World Forum for Harmonization of Vehicle Regulations

Proposal for a Supplement 3 to the 04 series of amendments to UN Regulation No. 79 (Steering equipment)

Submitted by the Working Party on Automated/Autonomous and Connected Vehicles*

“5.6.4.8.2. Detection area on ground level

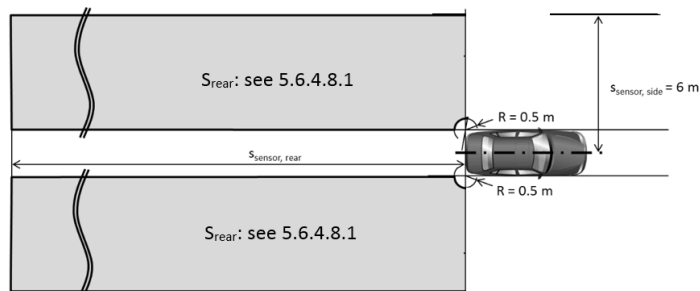
Paragraph 5.6.4.8.2., amend to read:

The vehicle system detection area on ground level shall be at minimum as shown in the figure below.”

2.1.2.3. Objects behind the towed vehicle

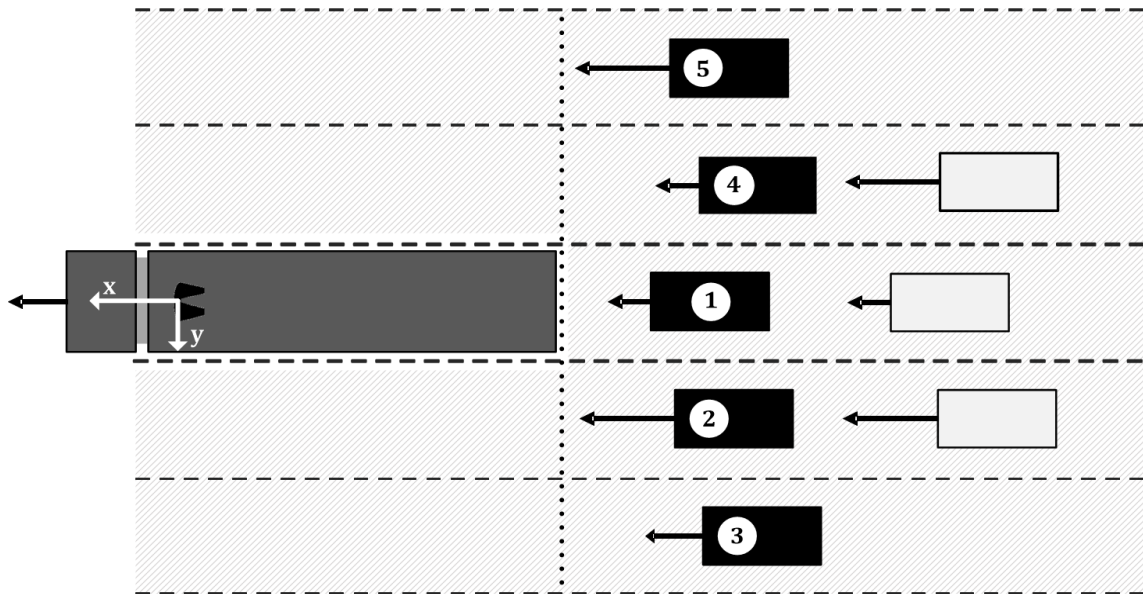
The area behind the towed vehicle is split into five ranges. From each range an object shall be selected, if present. If the absolute velocity of the towed vehicle > 10 km/h only moving objects shall be selected. An object is moving if its absolute velocity is not zero. The five ranges are specified by the lateral position relatively to the towed vehicle:

- (a) $-0.5 \times w - 7 \text{ m} \leq y < -0.5 \times w - 3.5 \text{ m}$
- (b) $-0.5 \times w - 3.5 \text{ m} \leq y < -0.5 \times w$
- (c) behind the towed vehicle
- (d) $0.5 \times w < y \leq 0.5 \times w + 3.5 \text{ m}$
- (e) $0.5 \times w + 3.5 \text{ m} < y \leq 0.5 \times w + 7 \text{ m}$

Where y is the lateral position [m] and w is the width [m] of the towed vehicle.
